PLANNING BOARD SECOND MEETING AGENDA
CONDUCTED WITH ZOOM
DECEMBER 15, 2020 4:00 PM – TUESDAY

Re: Boro File No. MSPB-R1310
Variance – Stoma
Block 155, Lot 1
26 Pearce Court
R-3 Single-Family Residential Zone
Borough of Manasquan, Monmouth County, NJ

ALBERT D. YODAKIS, P.E., P.P.
MANASQUAN PLANNING BOARD
ENGINEER

TOPOGRAPHIC SURVEY
FOR

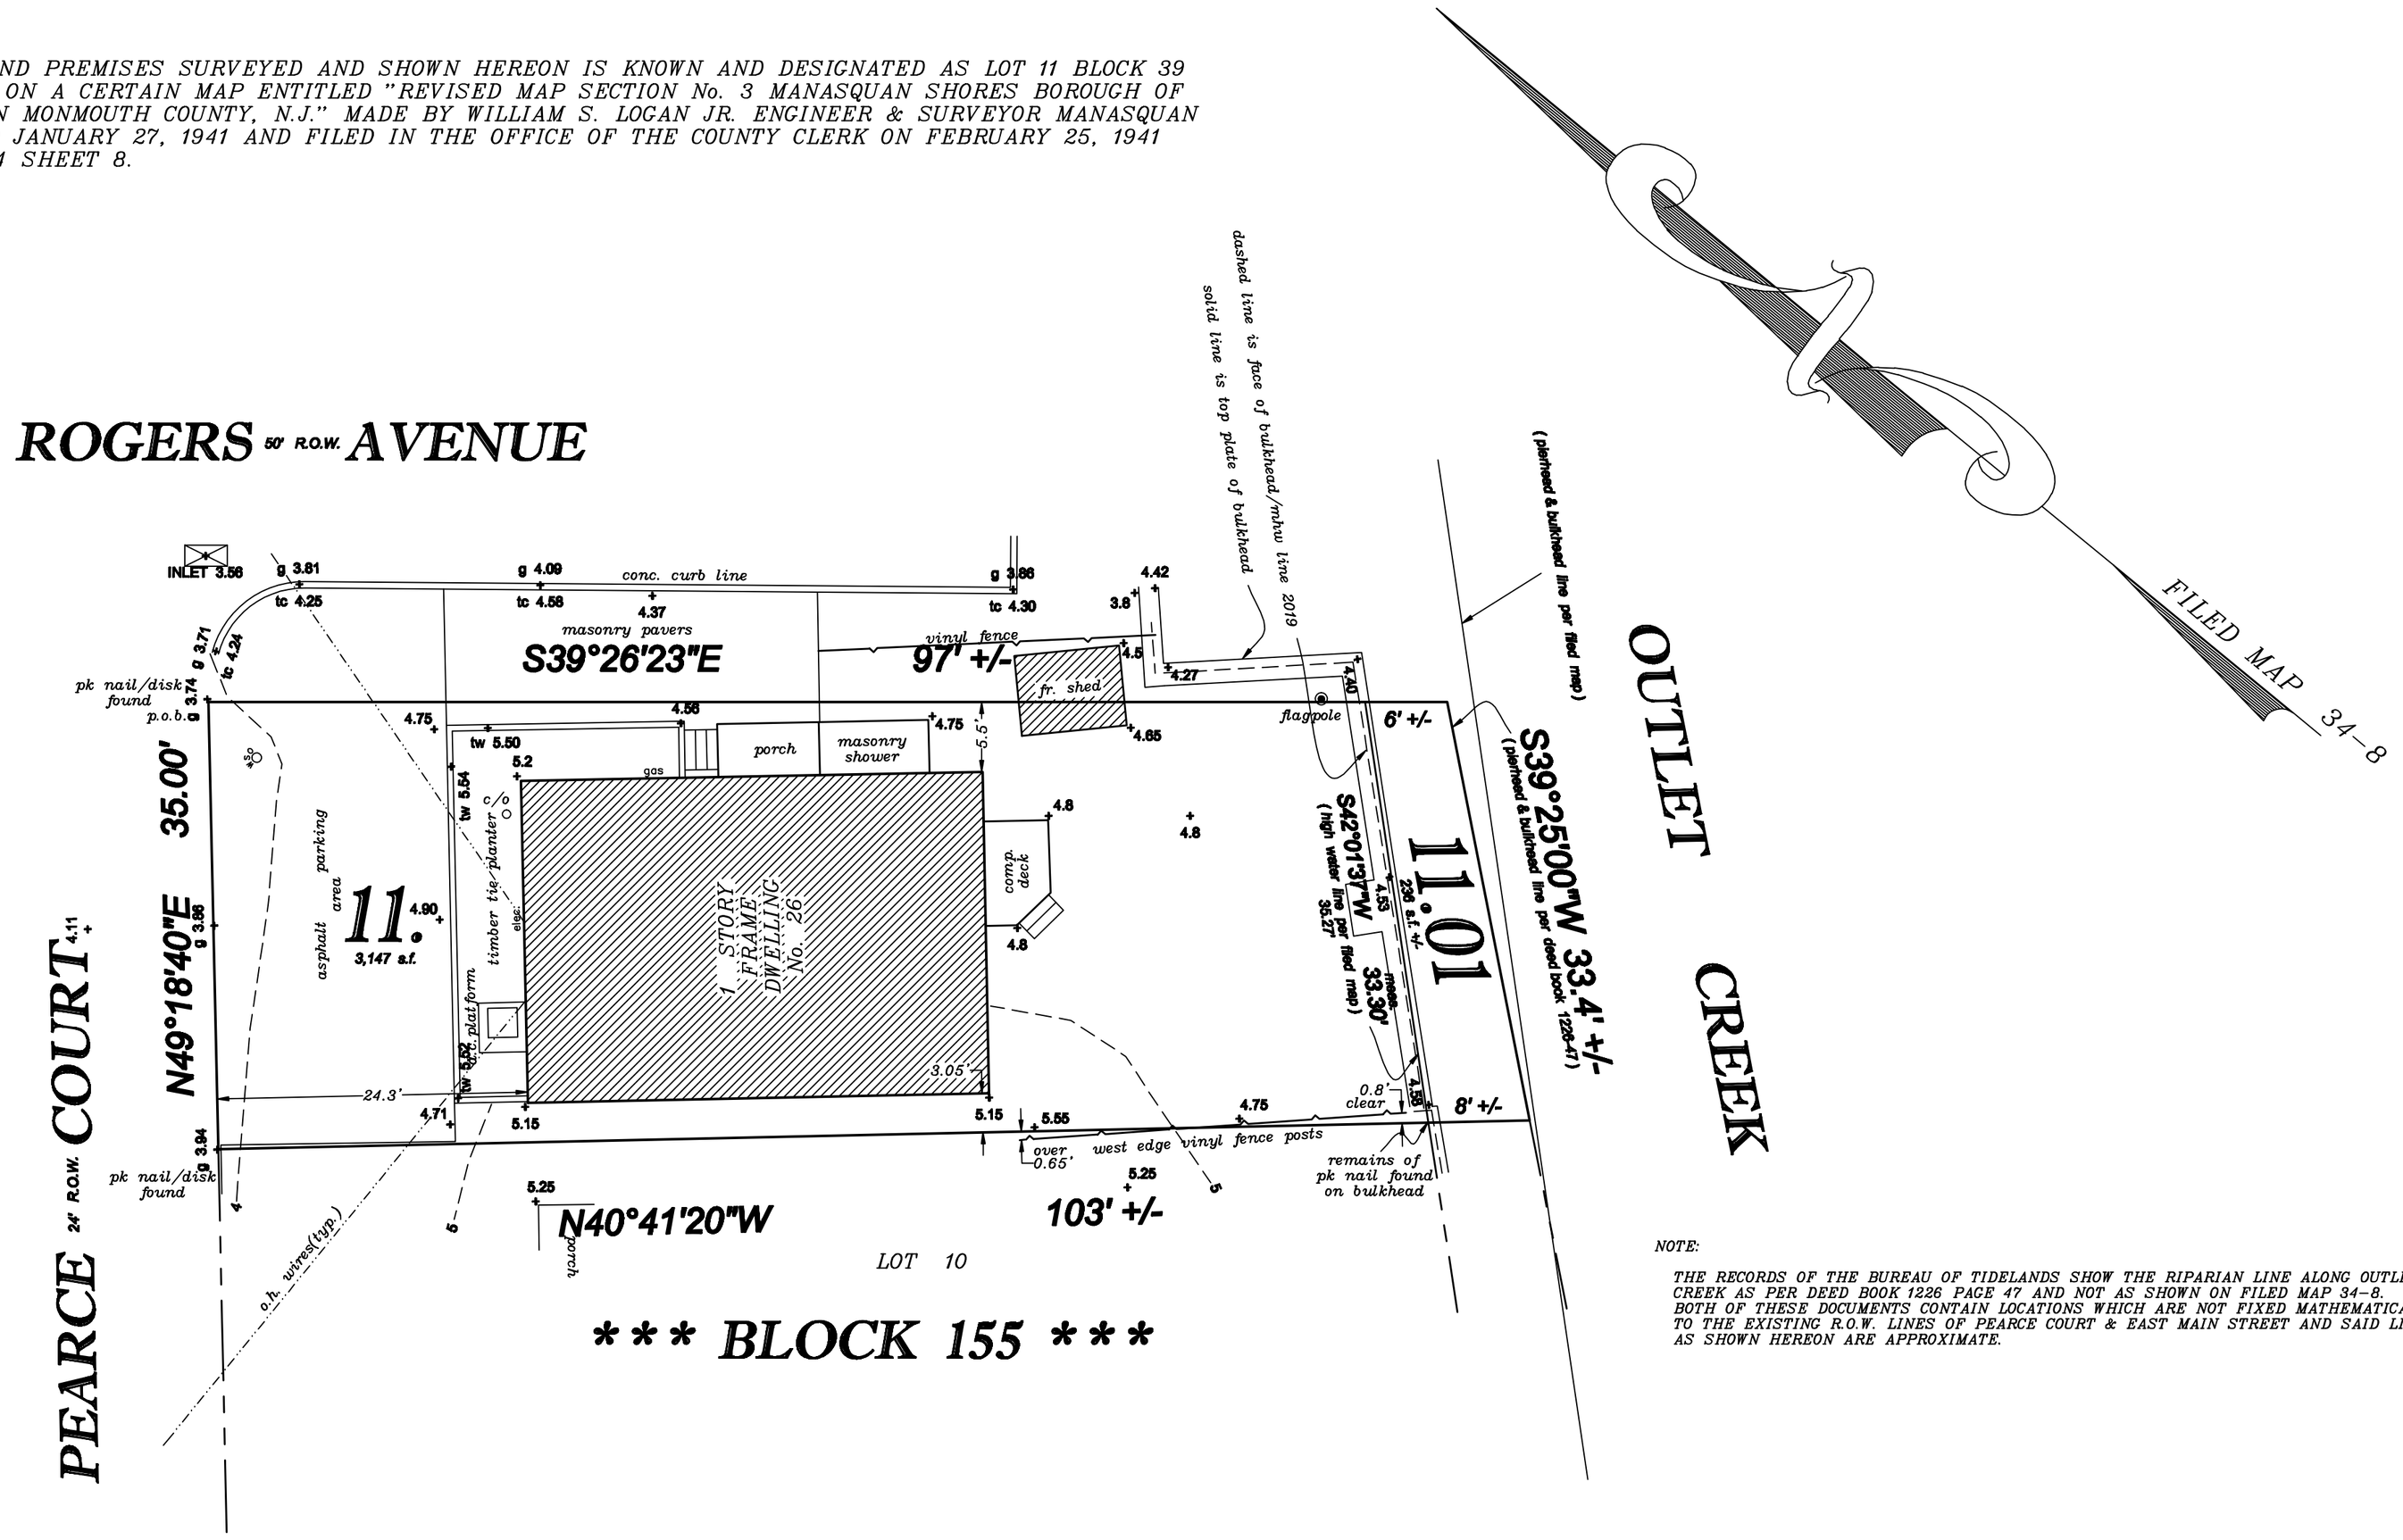
4. The submitted survey shows and existing shed, fence, and pavers within the borough right-of-way. The intent of the improvements to remain or be removed should be indicated. The plans also show the side entrance steps/landing within the right-of-way which will require borough approval.

PLOT PLAN
131 THIRD AVENUE
BLOCK 169.05 - LOT 61
FOR CINTHIA WEAVER

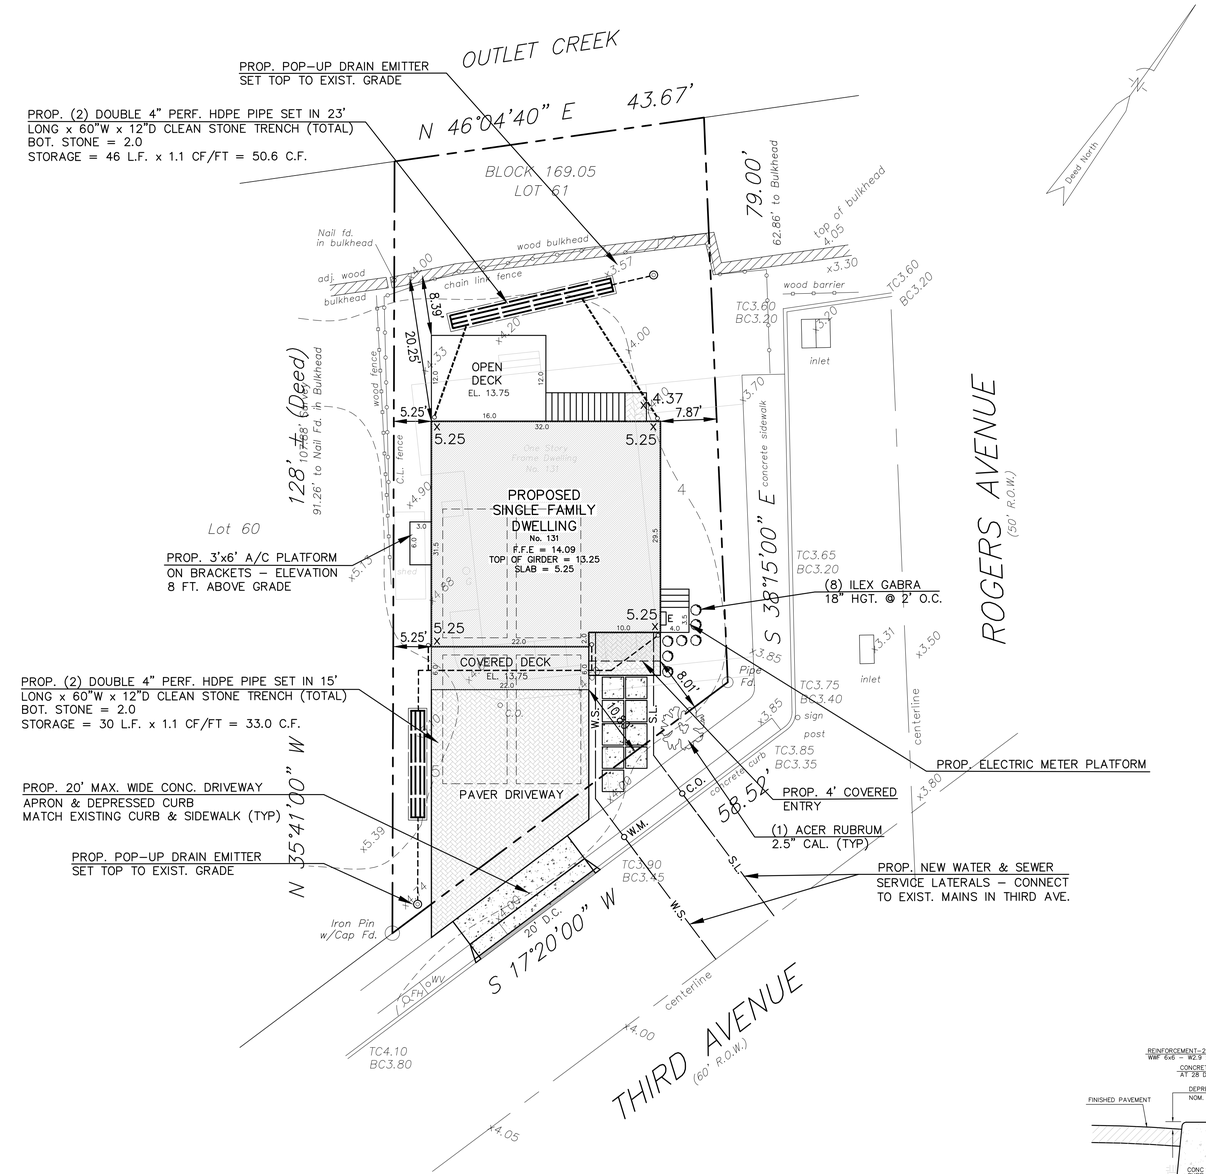
Section 35-9.4 – Front Setback – 25ft. Required
18.47ft. Average
6.5ft. Proposed

" - Rear Setback – 20ft. Required
8.39 Proposed to rear deck

Section 35-11.8c – Prohibits locating any mechanical equipment (A/C condensers) in the required side setback area.

Section 28-1.3 – requires that the drywell(s) must meet the minimum storage requirements.

1 ASP1.0 CONCEPT ARCH SITE PLAN
SCALE: 1" = 10'-0"

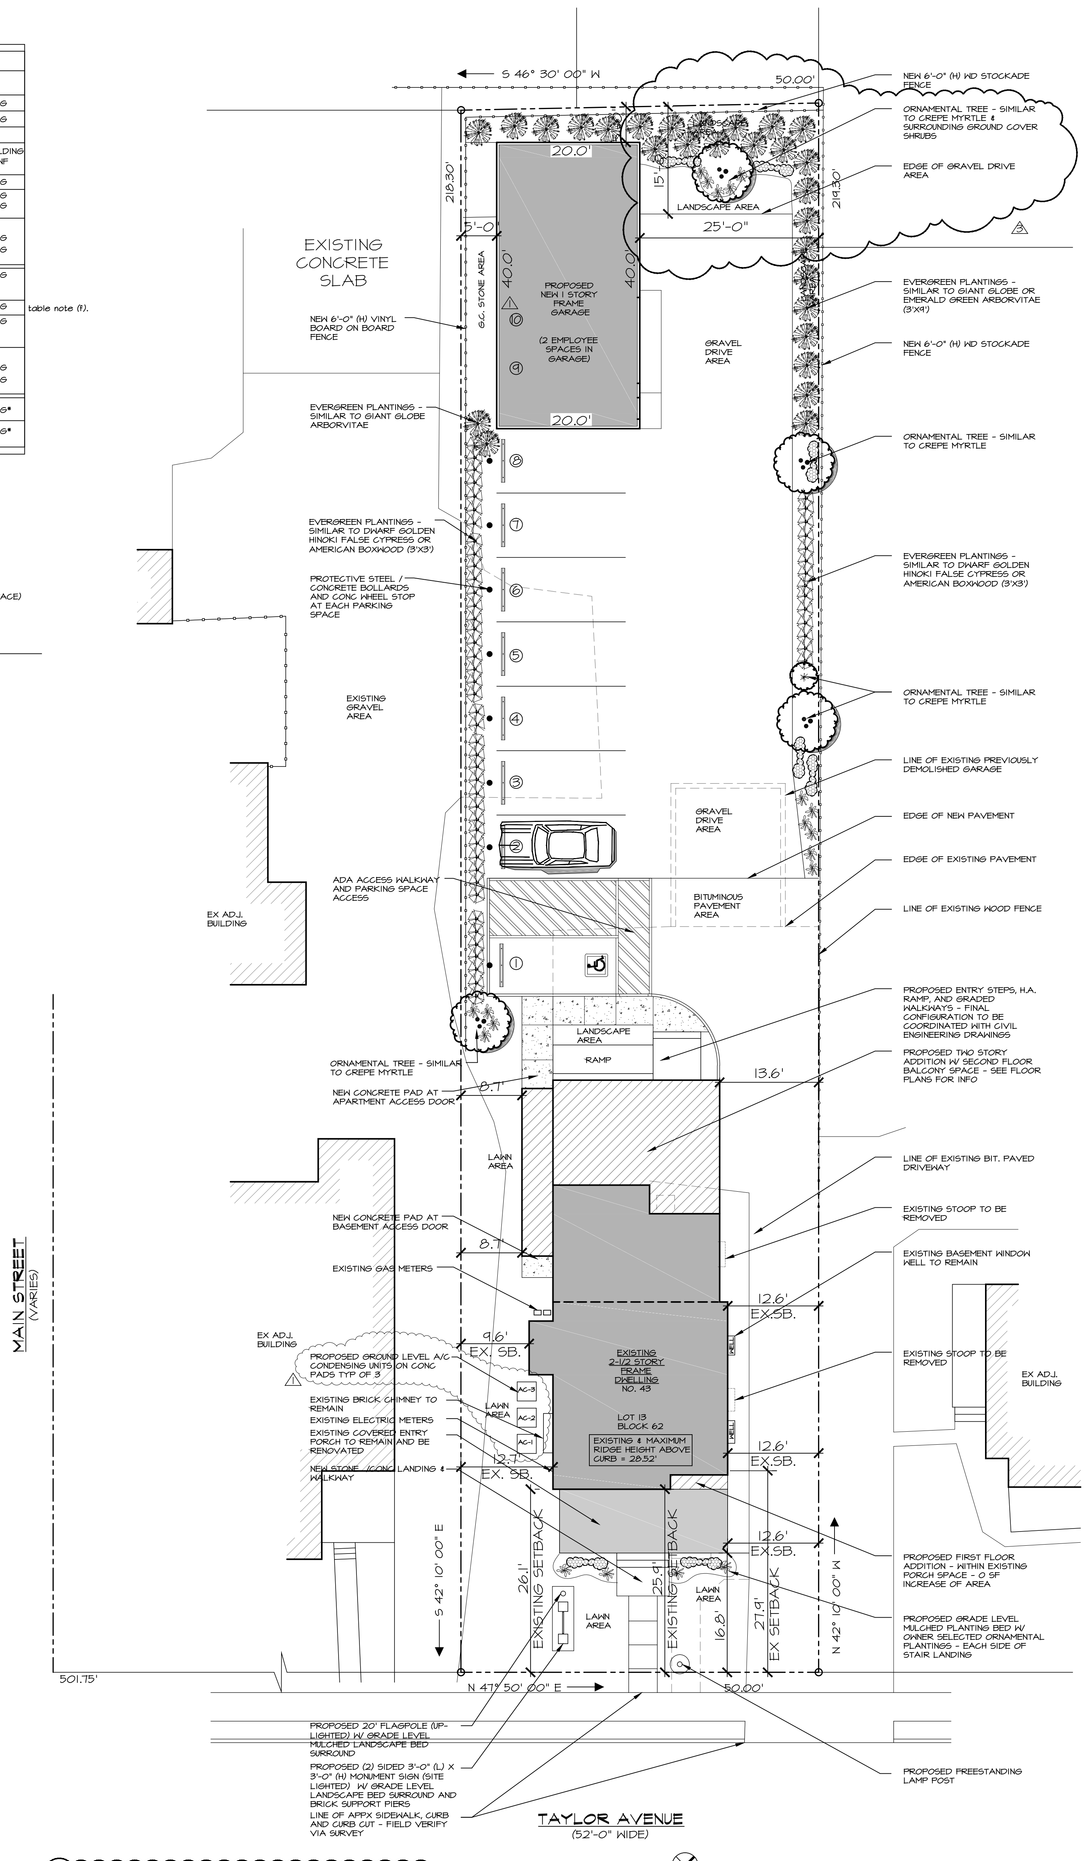
13. A revised landscaping plan should be submitted as the landscaping plan on the architectural layout does not match the current site plan.

1 G1.0 GARAGE FOUNDATION PLAN
SCALE: 1/4" = 1'-0"

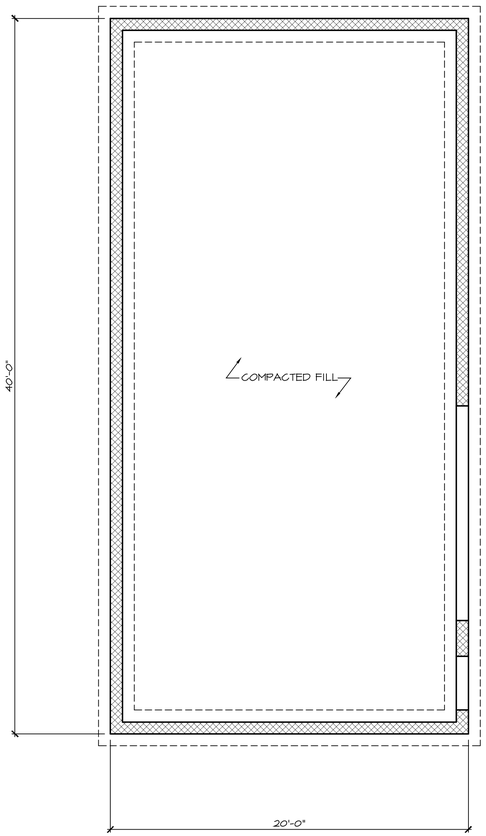
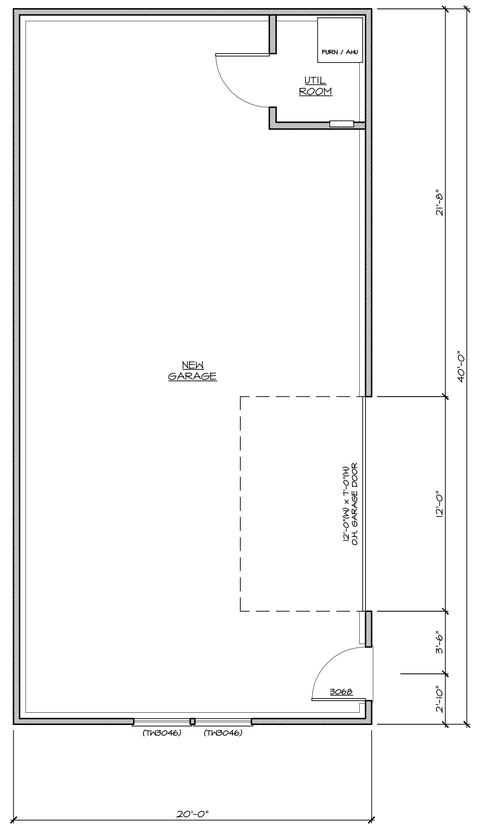
14. The architectural layout for the garage may need to be revised as the doors and windows do not seem to correspond to the current layout. Also, any concrete entry landings for the door or garage door should be shown on the site plan.

SITE PLAN

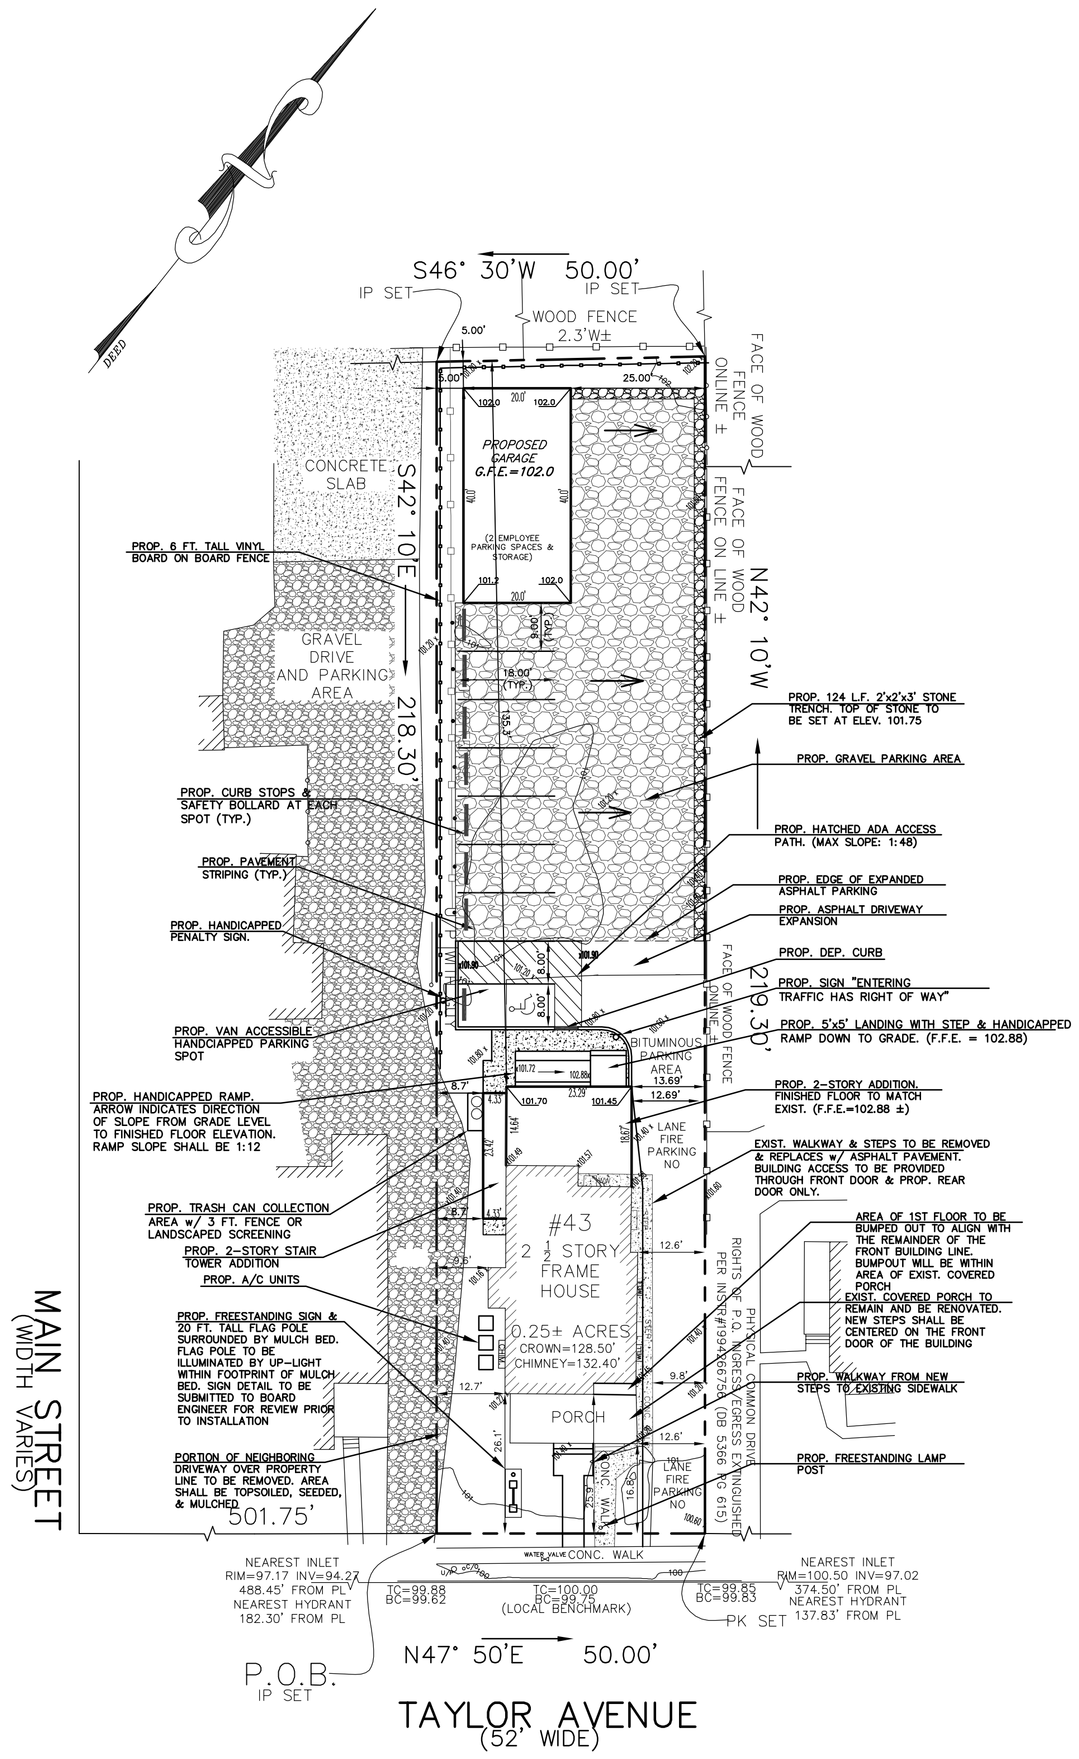
6. The continued use of the shared driveway with adjacent Lot 14 should be discussed with the Board. If an easement exists, it should be shown on the plan. Also, the repaving of the driveway will need appropriate milling so as to not change the elevation an affect the adjacent property and driveway.

9. The drainage report states that there are drywells to address stormwater runoff from the proposed detached garage. The location of the drywells must be provided on the plans as well as sizing calculations.

10. The applicant should provide an explanation of the following items:
    - Proposed hours of operation of the businesses
    - Anticipated types of deliveries and turn around movements for large vehicles
    - Proposed delivery hours and garbage collection times
    - Proposed hours of operation of the site lighting

16. Any building mounted lighting or parking lot lighting must be shown on the plan. Also, the flag pole and lamppost should be shielded to prevent glare to adjacent properties.
